SB-927R

## SERVICE BULLETIN AMATEUR RADIO

RC-10 ALTERNATOR NOISE

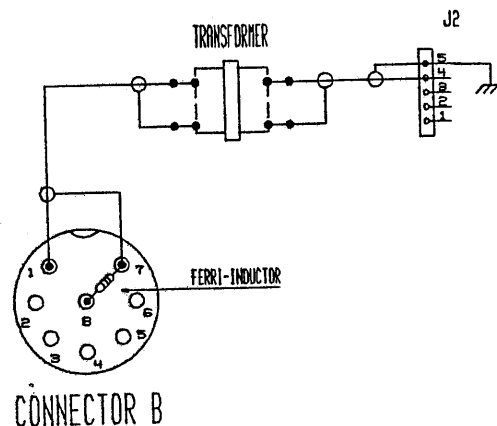
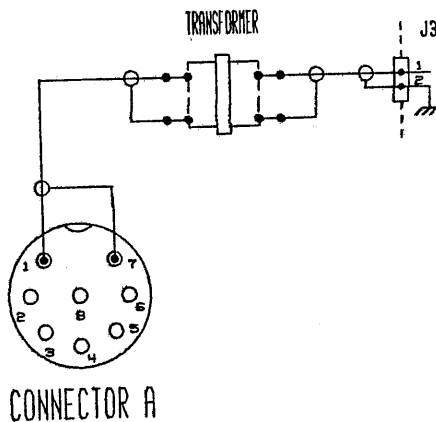
When two transceivers are connected to the RC-10, alternator noise may be induced in the mic circuits. The following modification will correct this condition.

1. Remove the base plate from the RC-10 (6 screws on the plate; 1 screw on the back panel).
2. Add the ferri-inductor between pins 7 and 8 of connector B as shown below.
3. Locate connectors J2 and J3 on the AF unit (X49-3010-XX B/3).
4. Add a transformer in each mic circuit as shown below.
5. Using double sided tape, secure each transformer to the side wall of the base.
